SHD0014/22 Junction of Santry Avenue & Swords Road, Santry, Dublin 9.

Comments by DCC Parks, Biodiversity & Landscape Services

August 19th 2022

Proposed Master Landscape Plan

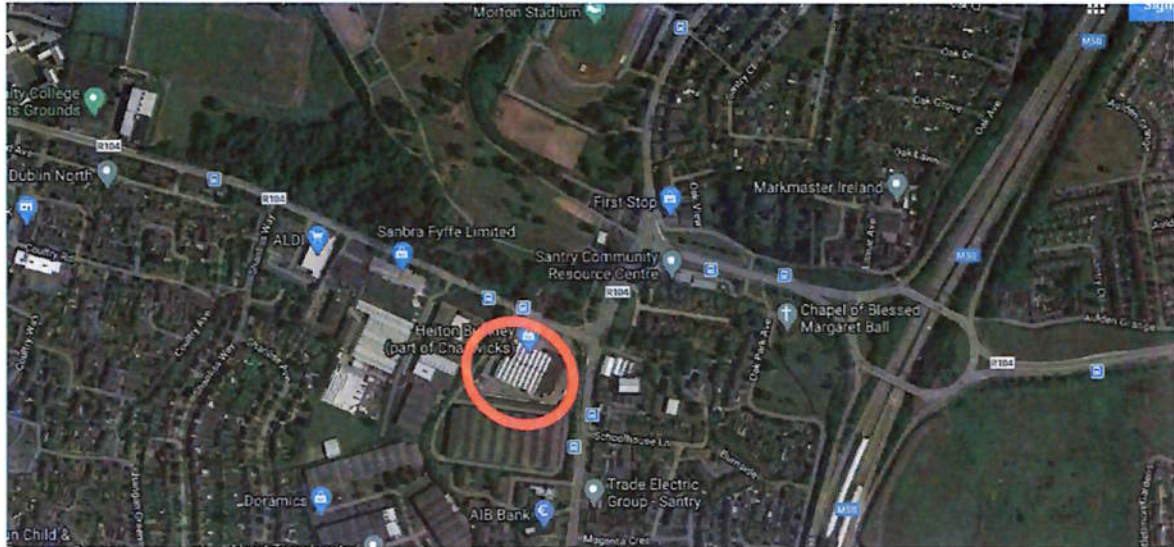
The application proposes development of 350 apartments with commercial/retail on a mixed use development site (approx. 1.5ha), which is zoned Z3 *To provide for and improve neighbourhood facilities*. The development layout proposes 7 blocks with a north-south orientation parallel to the Swords Road. A landscape architectural submission has been submitted which is well developed and indicates open space distributed between the proposed blocks as well as streetscape proposals. Public open space is located through the centre of the scheme and provides a public route towards Santry Park.

3.1 Existing trees

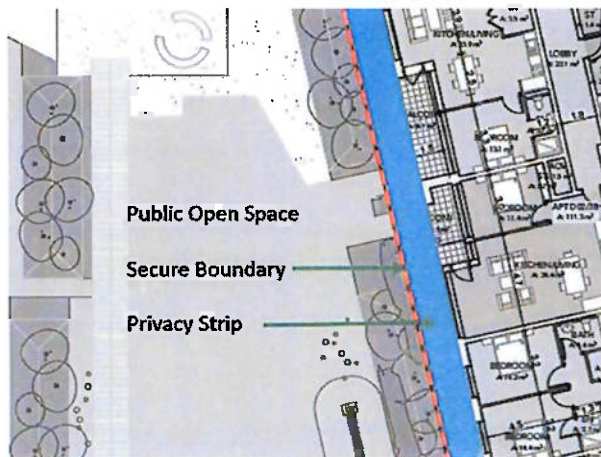
A tree bond will be required to enhance protection of existing trees to be retained, which includes the row of public street trees on the eastern boundary. The tree protection plan is satisfactory and should form part of any development permission's conditions.

3.3 Sunlight/Daylight Assessment

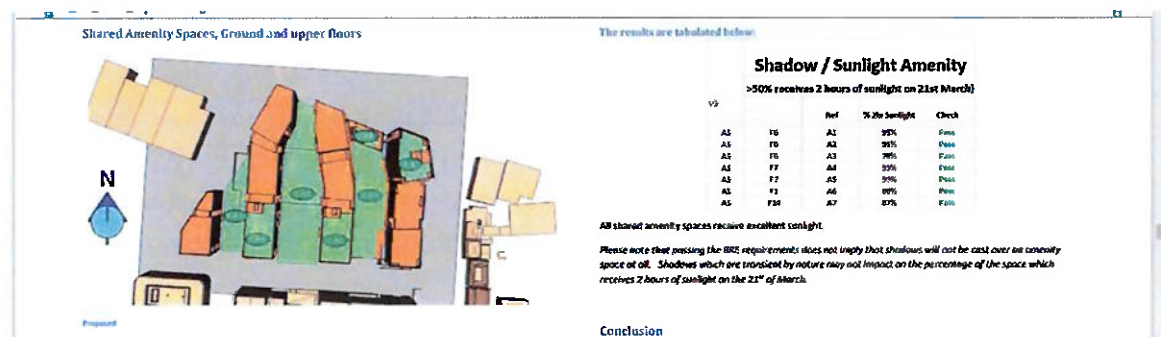
The assessment results indicate both POS and COS (below) as satisfactory with regards the March 21st threshold requirement.
